**FORM VT-3C**  
 CONTAINMENT INSERVICE INSPECTION  
 RECORD OF VT-3C EXAMINATION

STATION/UNIT: Indian Point 2 COMPONENT NO.: VCC-35  
 ZONE NUMBER: IWL-148-006 DRAWING NO.: 320869  
 EQUIPMENT USED: Celestron Giant 20x80 Binoculars (Ser. No. 990176)

00060103.jpg

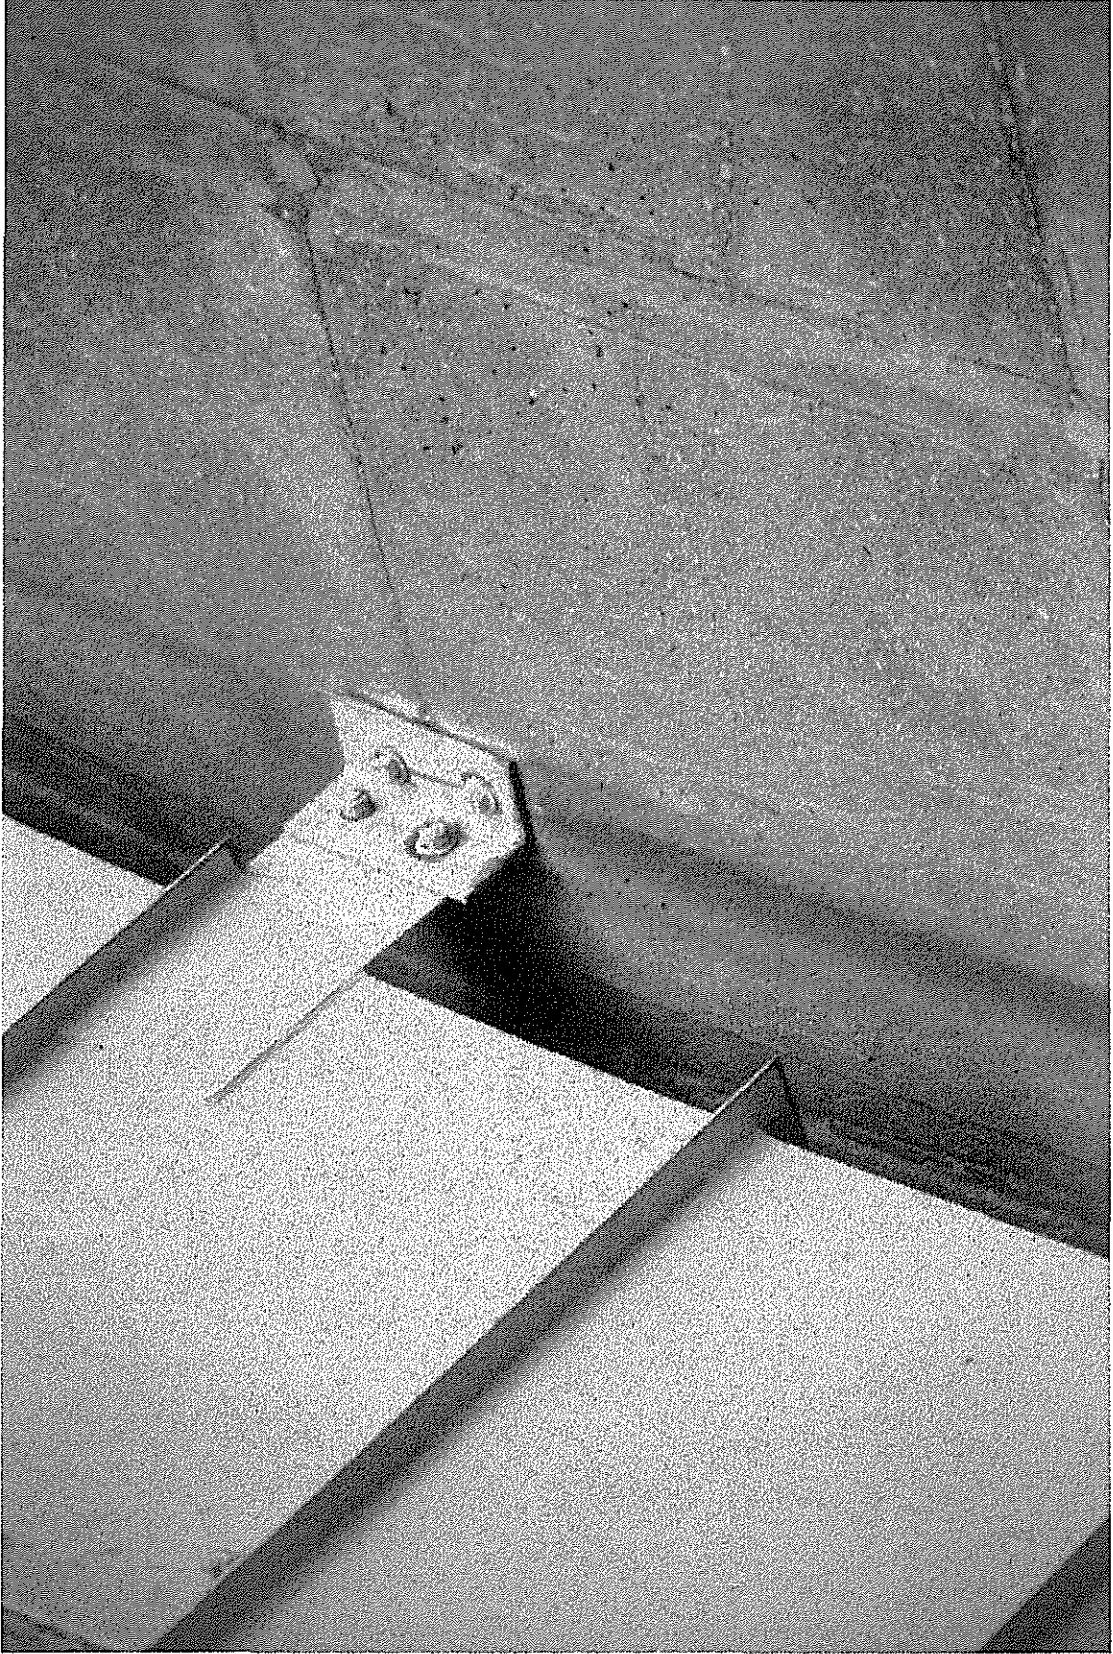
No.	Comment	Initials
1	Large rust stains are evident on the surface of the dome at and below the concrete pier which supports the lightning rod. The rust is obviously dripping down from the lightning rod base support plate. No cracking is evident in the area so rebar corrosion is not suspected. Corrosion staining is also evident at surface attachments for the discharge duct due to rusting of the attachment plates. See photo 00060104	RW
2	4' long horizontal crack and about 20 to 30 mils in width, 15" above the dome spring line. See photo 00060103	RN
3	3" diameter void (shallow hole) under the duct edge. See photo 00060106	RN

00060105.jpg

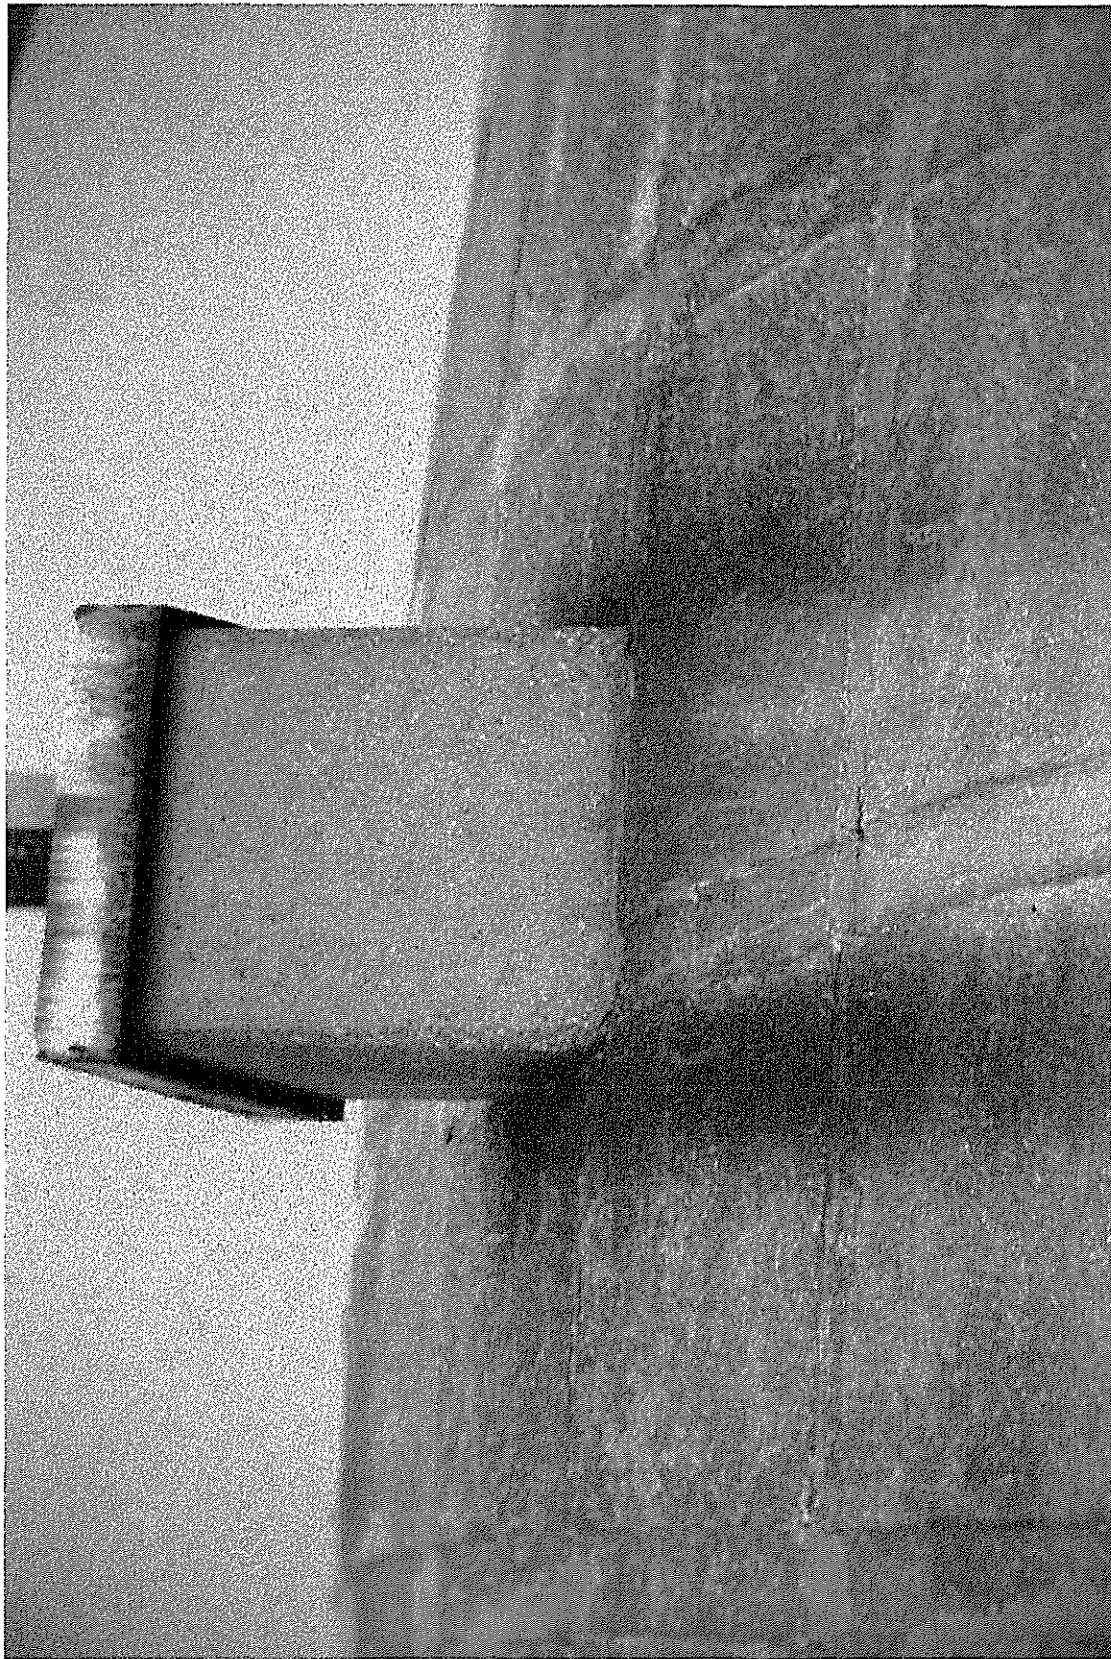
No.	Comment	Initials
1	Large rust stains are evident on the surface of the dome at and below the concrete pier which supports the lightning rod. The rust is obviously dripping down from the lightning rod base support plate. No cracking is evident in the area so rebar corrosion is not suspected. See photo 00060105	RN

**CONCRETE INSPECTION ZONE IWL-DOME-007**  
 (EXTERIOR DEVELOPED VIEW, LOOKING FROM OUTSIDE)

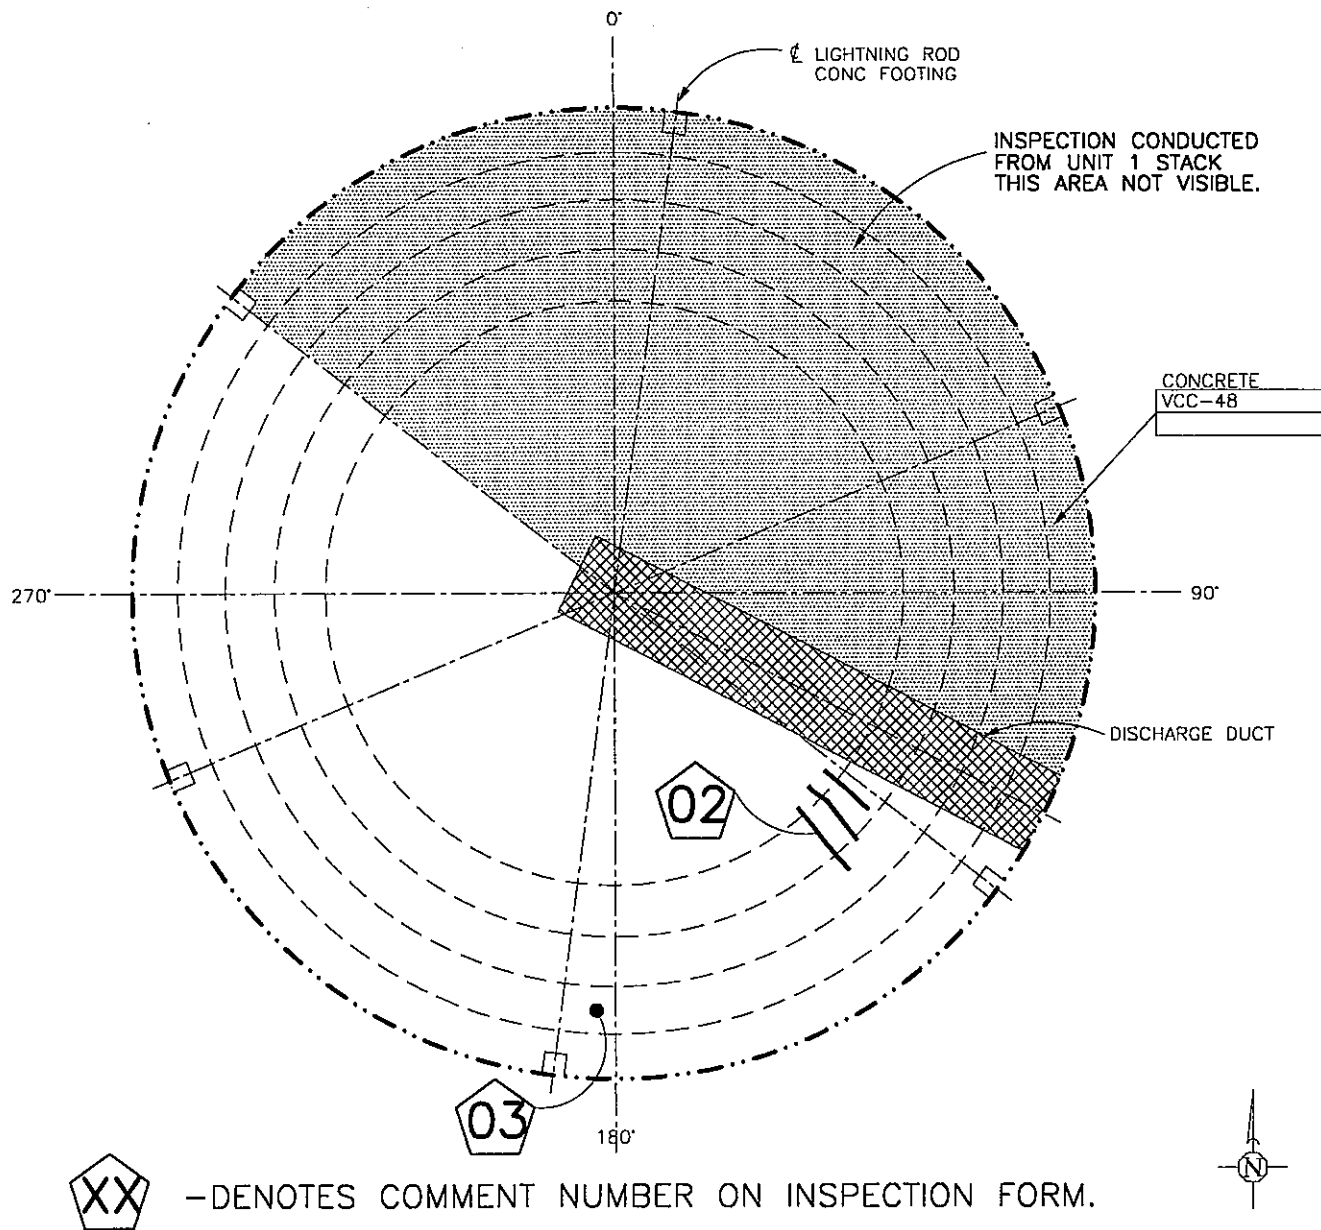
No.	Comment	Initials
1	Large rust stains are evident on the surface of the dome at and below the concrete piers which supports the lightning rods. The rust is obviously dripping down from the lightning rod base support plate. No cracking is evident in the area so rebar corrosion is not suspected. Corrosion staining is also evident at surface attachments for the discharge duct due to rusting of the attachment plates. See photo 00053145	CAS
2	Three (3) rust streaks (6' to 8' long) are present in the upper part of the dome at approximate Azimuth 135. There is no obvious source of these streaks but there is no concrete cracking or other signs to indicate that the corrosion originates from reinforcing steel.	CAS
3	A shallow spall approximately 18" in diameter is present approximately at Azimuth 180 just above and to the east of the lightning rod foundation.	CAS

Comments: Engineering evaluation is needed to evaluate the significance of the spalled area (comment #3).
